## Technical Bulletin

Bulletin No	10	2014-02	Issued: 022014	Revised:	Page 1 of 3
Equipment	1 Gallon Bail-O-Matic				
Topic	Retro-Fit Rear Hinge

**Assembly # 10.09.002**

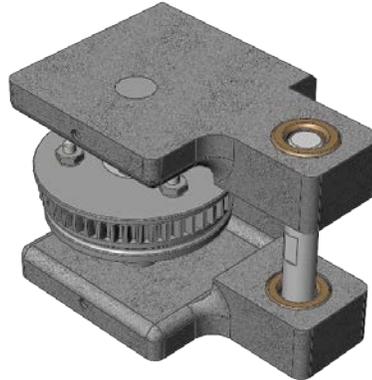
**Issues: Older Style Hinge required too much maintenance causing:**

1. Inconsistent Wire Drive/Straightness/Length.
2. Poor operation from excess wear of the older woodruff-key style Rear Hinge parts.
3. Excess repair time and costs maintaining the parts required for smooth operation.

**A low-cost direct-fit replacement Retro-Fit Rear Hinge is available.**

**It comes with an easily-greasable hardened shaft, and needle bearing.**

It is a very important improvement to the wire feed system, that is economical, and greatly reduces the required maintenance to keep the wire drive, straightness, and length consistent.
